E3631A-09C

S E R V I C E N O T E

E3631A DC Power Supply

On +6V output unit shows current drawn without load

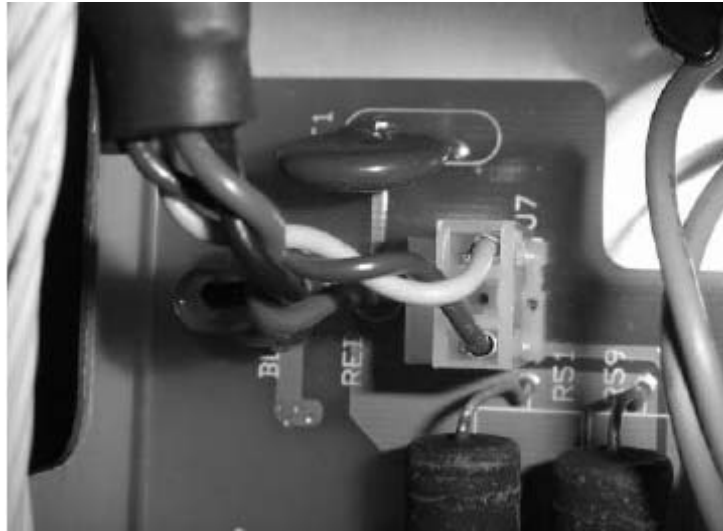
1. Solder the yellow and blue wires directly to J7 (part number: 1252-2786) on the E3631-60004 (Bottom PCA Board). Below pictures are showing the changes being performed.

Before – Yellow and Blue wires are connected to PCB with a connector jack.

Solution - Yellow and Blue wires are soldered directly to J7.

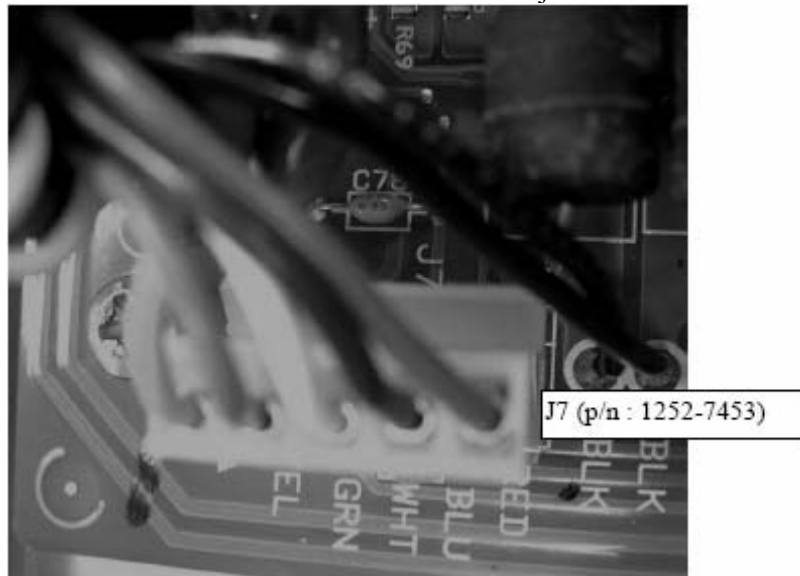
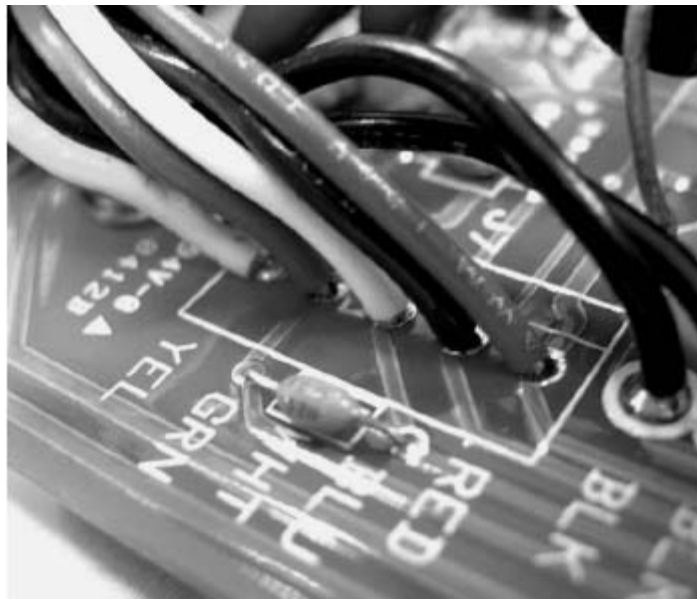
2. Remove J7 (part number 1252-7453) and solder the wires directly onto the PCB according to the colors indicated on the E3631-60002 (Top PCA Board).

Before – All 5 wires are connected to PCB within a connector jack.

Solution – All 5 wires soldered directly to PCB board according to the indicated colors.

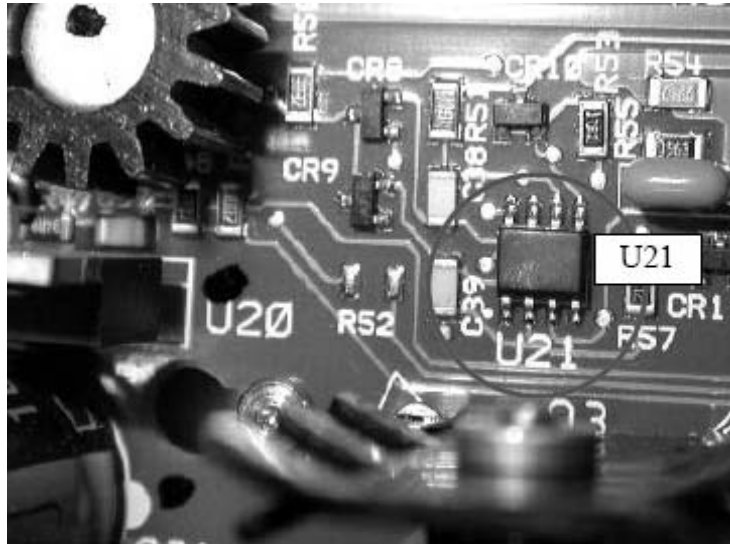
3. Change the U21 from part number 1826-1862 to part number 1826-2420 on E3631-60002 (Top PCA Board).

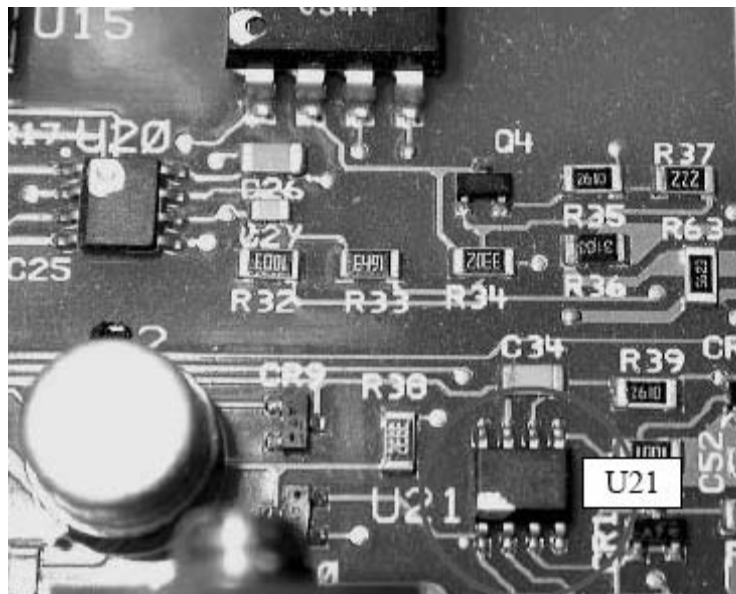
4. Change the U21 from part number 1826-1862 to part number 1826-2420 on E3631-60004 (Bottom PCA Board).

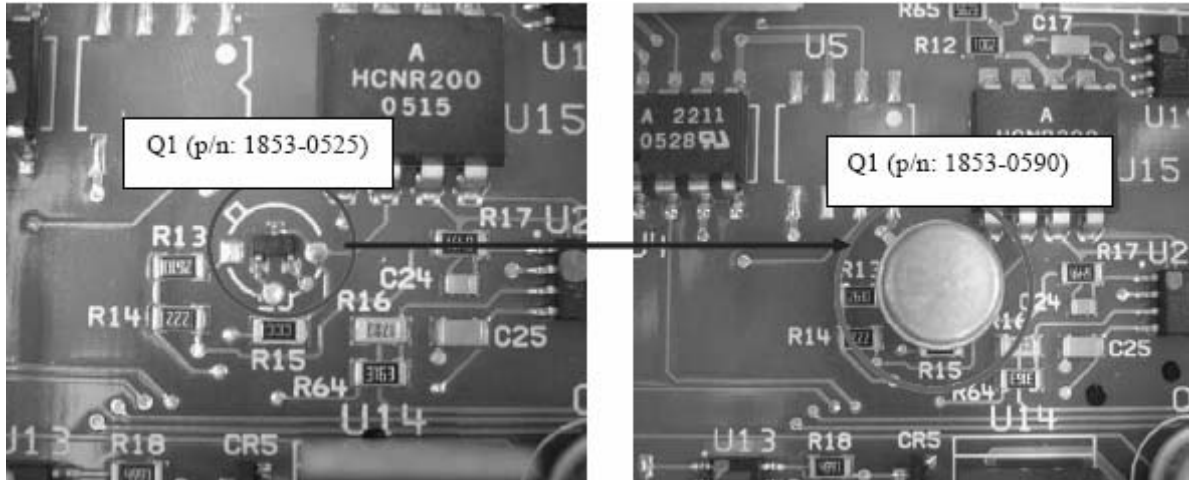
5. Change transistor Q1 from part number 1853-0525 to 1853-0590 on E3631-60004 (Bottom PCA Board).

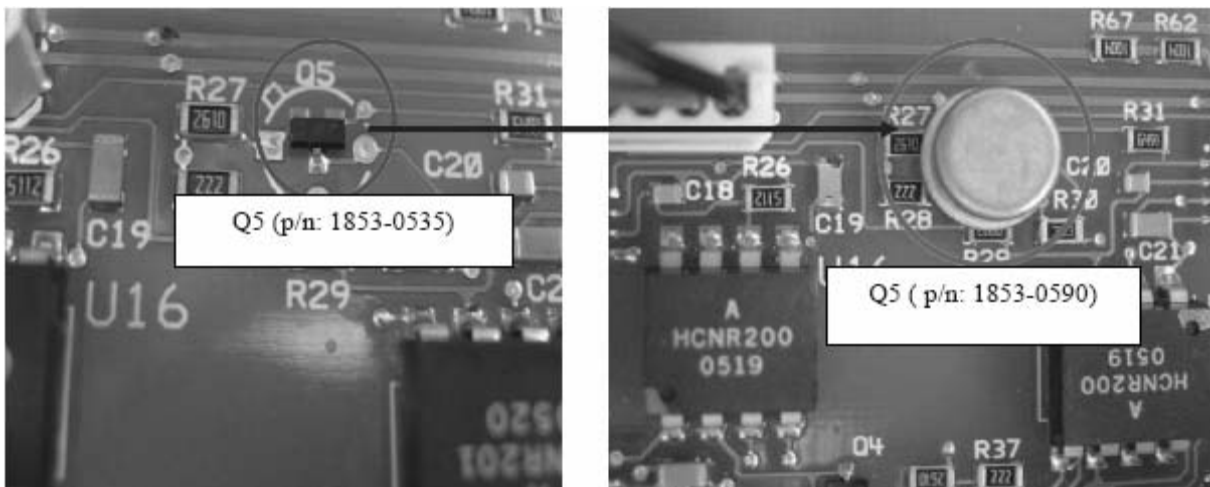
6. Change transistor Q5 from part number 1853-0525 to 1853-0590 on E3631-60004 (Bottom PCA Board).
